MARK	DATE	DESCRIPTIONS	BY	CH'D	CCO#
2	04/18/08	BARRIER MODIFICATIONS	GB	TH	44
1	08/24/07	BARRIER MODIFICATIONS	GB	TH	44

CONTRACT CHANGE ORDER NO. ____
SHEET ___ OF ___

SAN FRANCISCO OAKLAND BAY BRIDGE
EAST SPAN SEISMIC SAFETY PROJECT
SELF-ANCHORED SUSPENSION BRIDGE
(SUPERSTRUCTURE & TOWER)

BARRIER DETAILS NO. 1

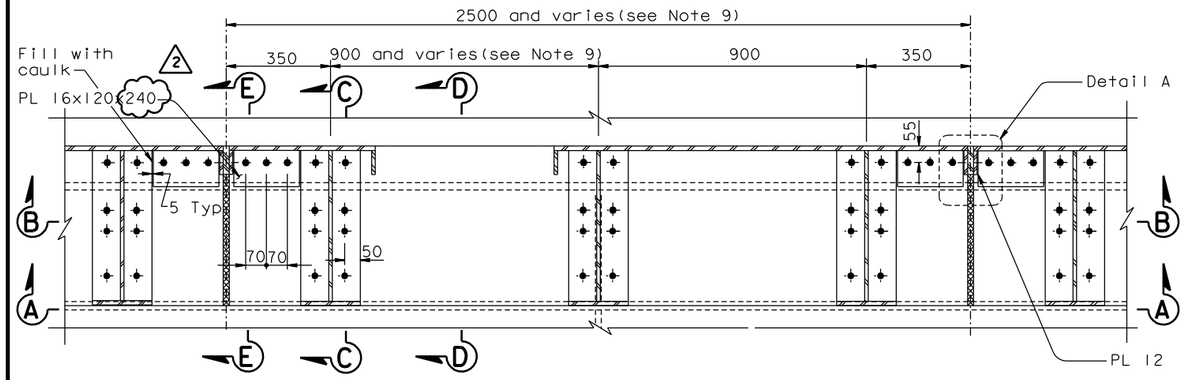
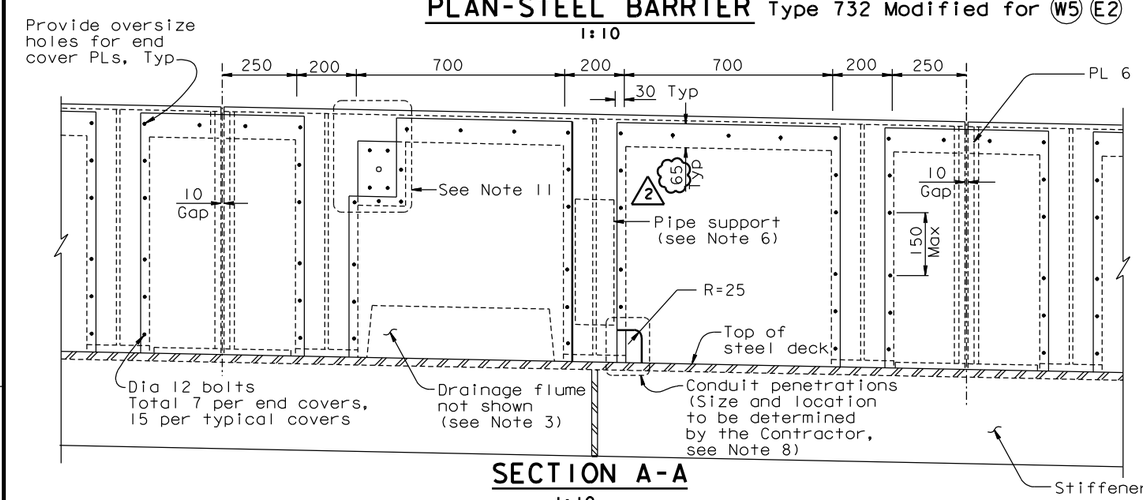
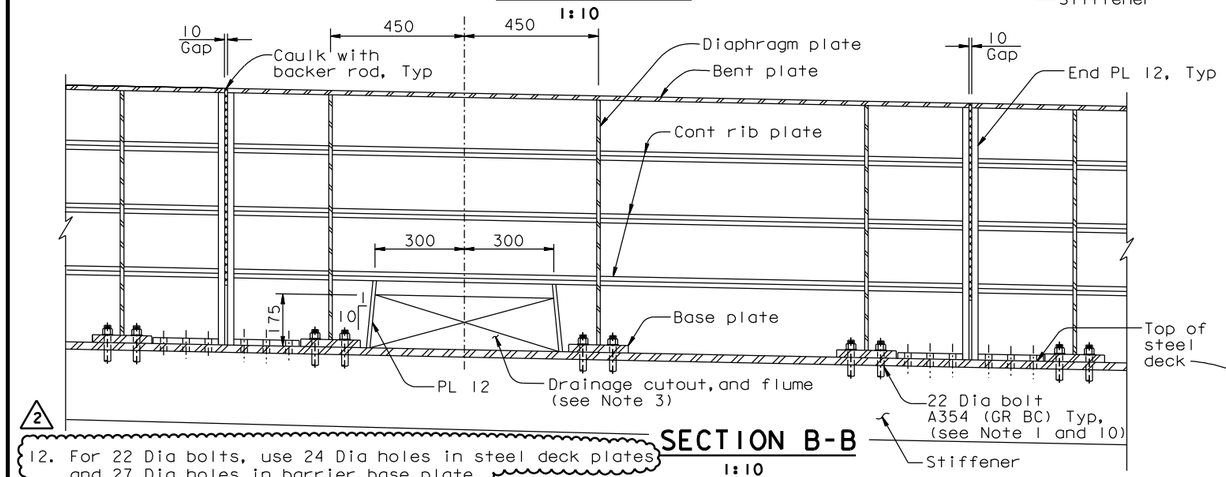
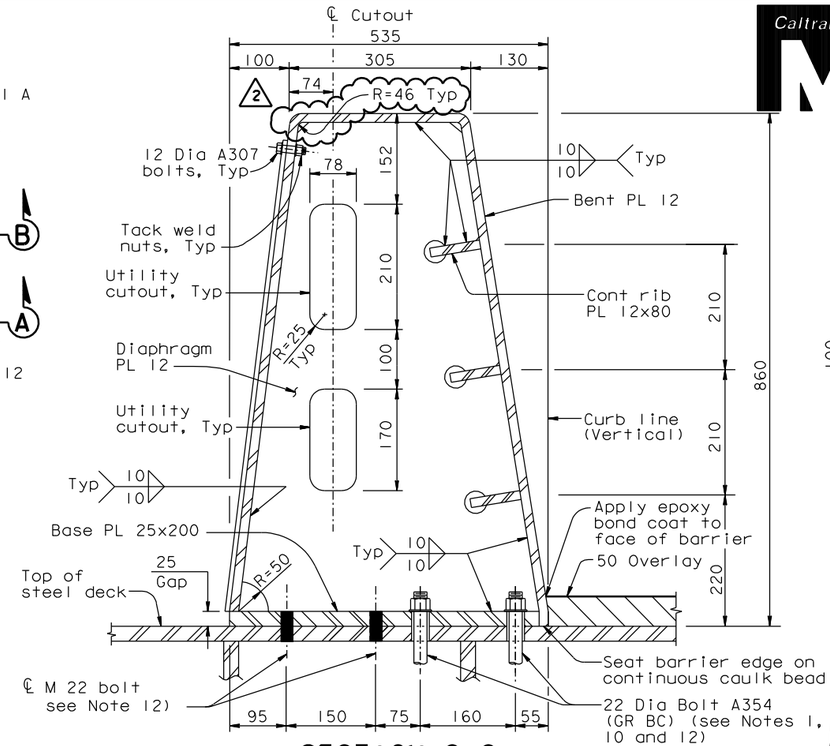
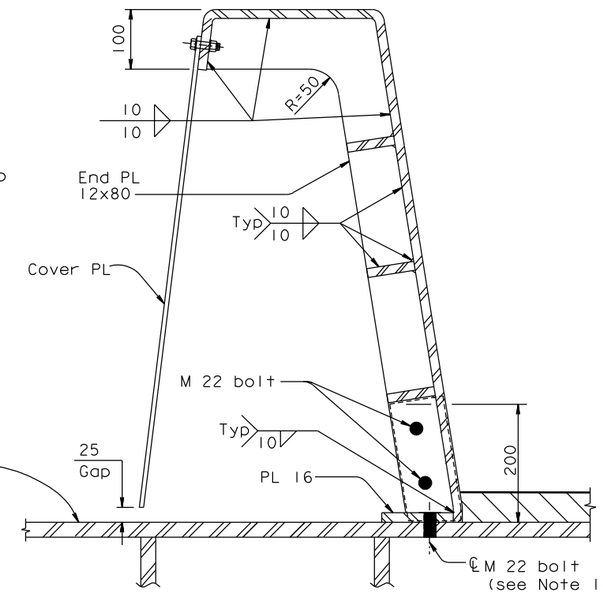
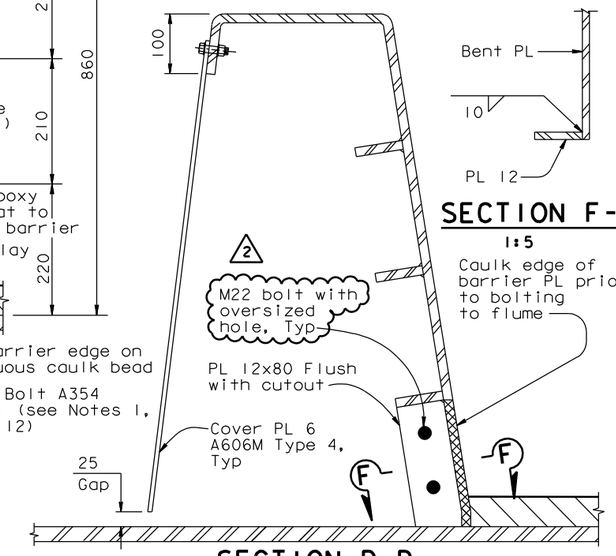
12. For 22 Dia bolts, use 24 Dia holes in steel deck plates and 27 Dia holes in barrier base plate.
13. For conduit and box support details, see "Road Plans".
